# SUNSET VILLAGE FILING NO. 4

## CONSTRUCTION PLANS

**CONSTRUCTION DRAWINGS AMENDMENT, DATED APRIL 4, 2026 BY ENGINEERING LOCAL XPERTS, LLC.**

OUTLET STRUCTURE DETAILS

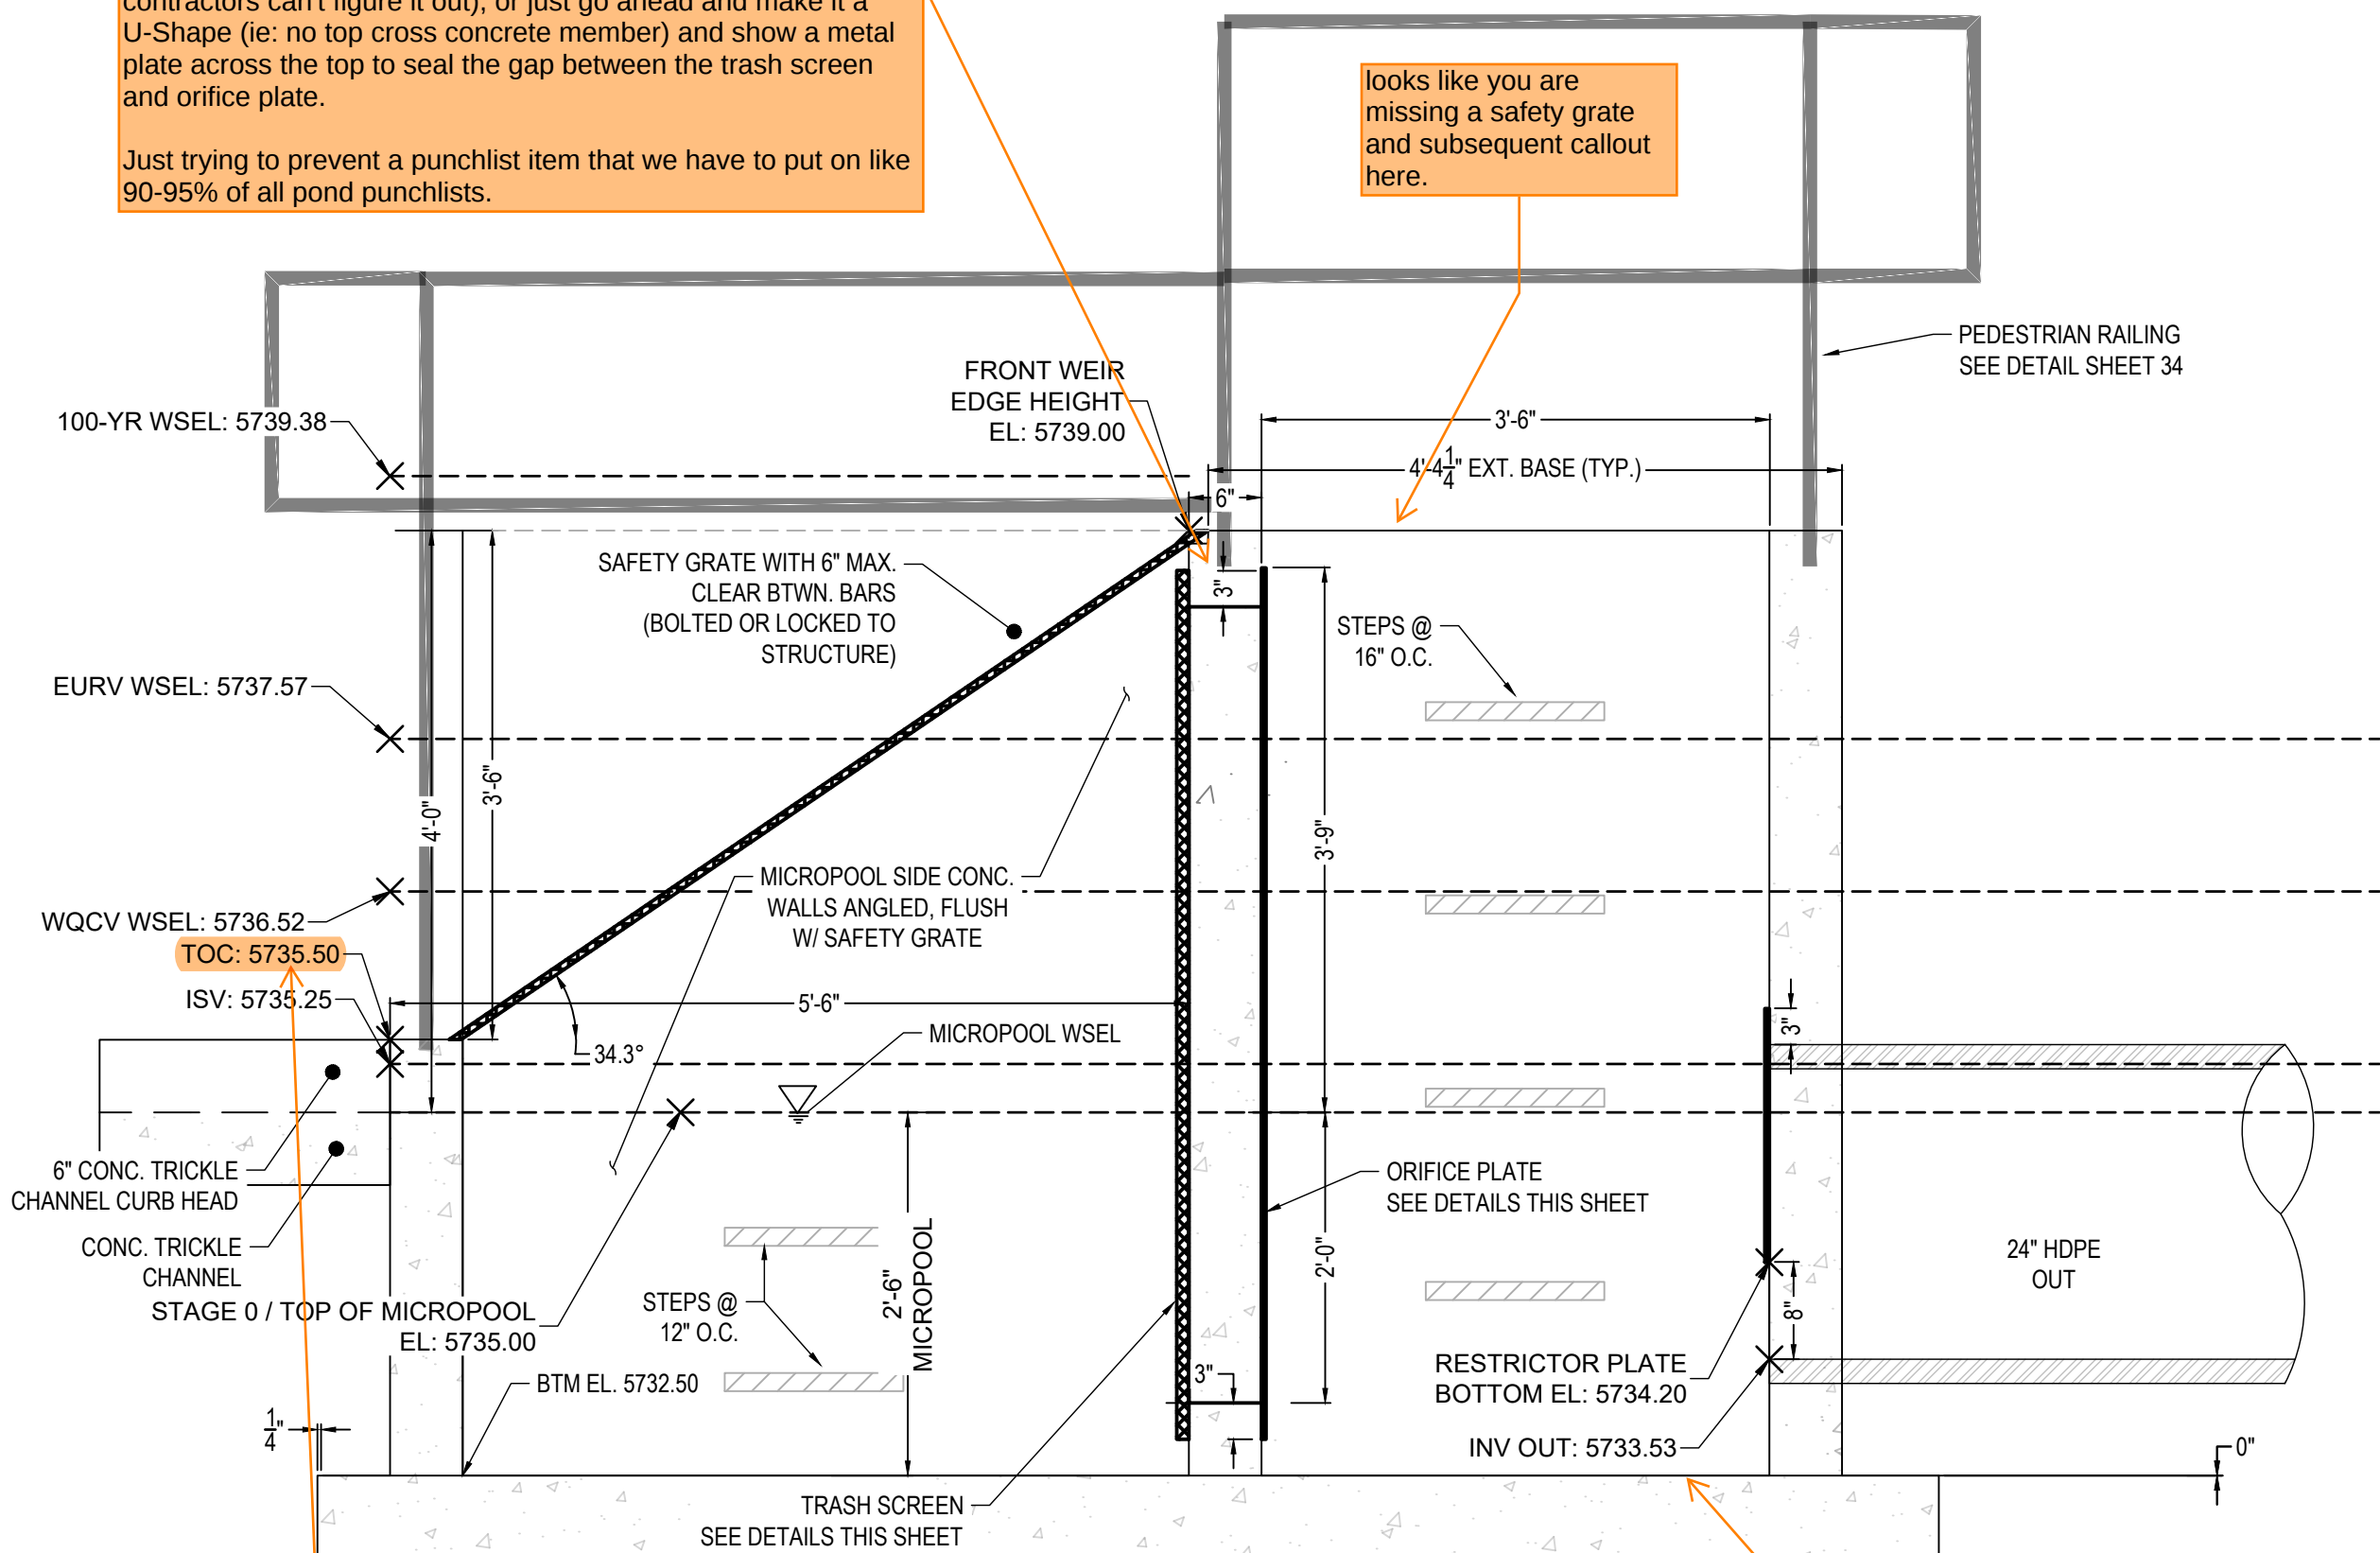
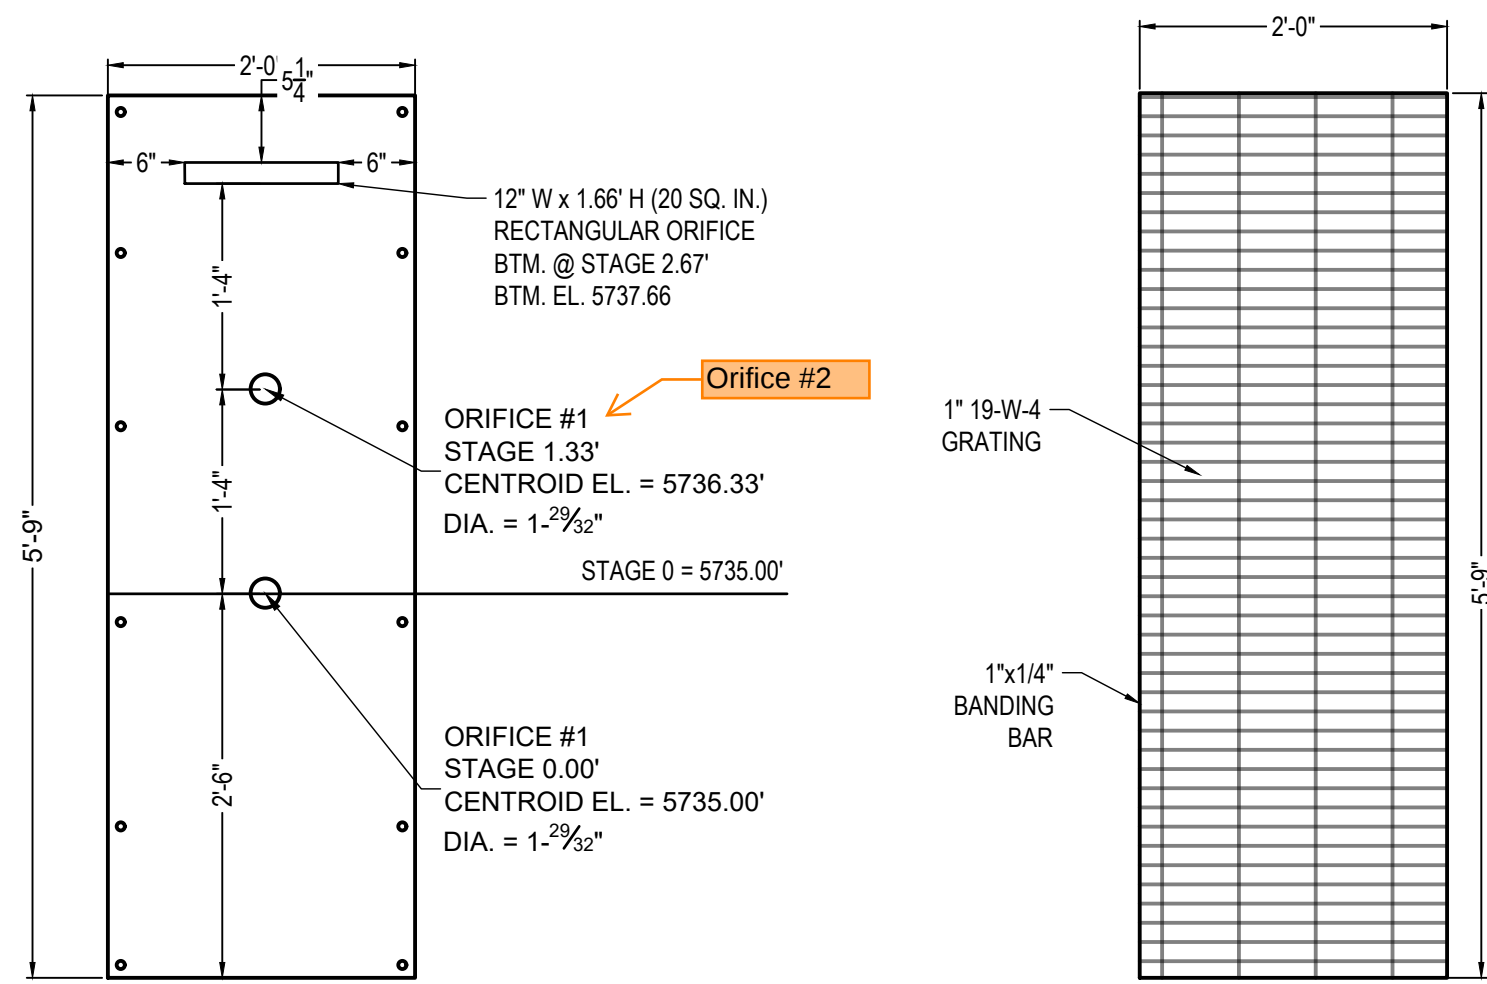
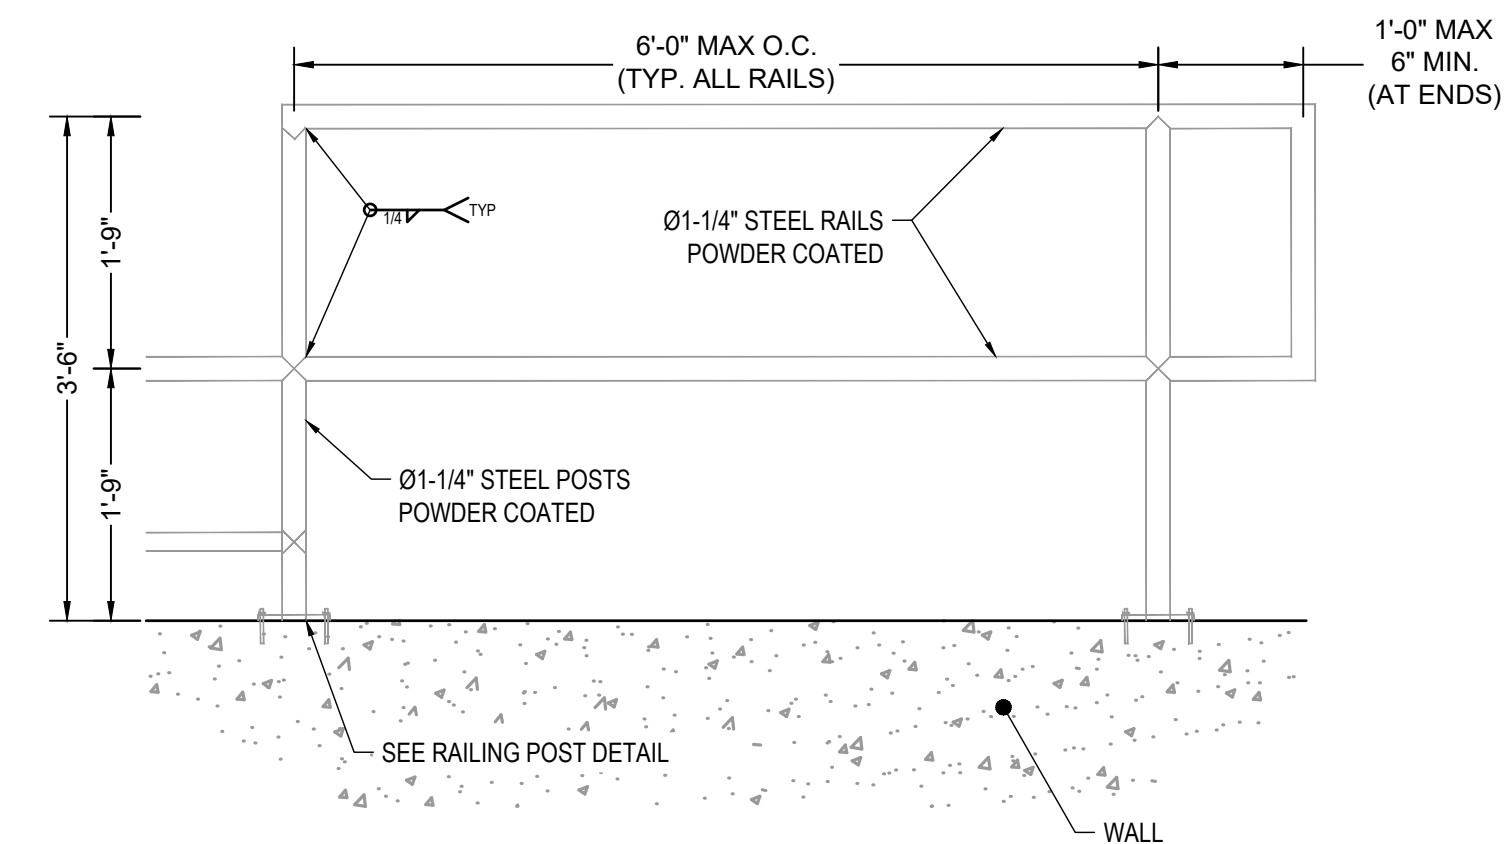
Basically every contractor constructs this opening for the orifice plate without the top concrete cross piece, creating a U-shaped opening, not a rectangular opening. This causes field fixes to be installed that are not ideal because it's better to do it correctly and per design than a retrofit. So either highlight this and call it out as something install carefully or in a particular way to make it clear how it's to be installed (because for whatever reason contractors can't figure it out), or just go ahead and make it a U-Shape (ie: no top cross concrete member) and show a metal plate across the top to seal the gap between the trash screen and orifice plate.

It's not ideal to have this area hold water. Recommend showing it filled with grout, angled towards the outlet pipe. Specifically: Per previous MHFD DCMv3 Detail T-12, the outlet structure bottom should have a shaped invert of 2.5% minimum slope.
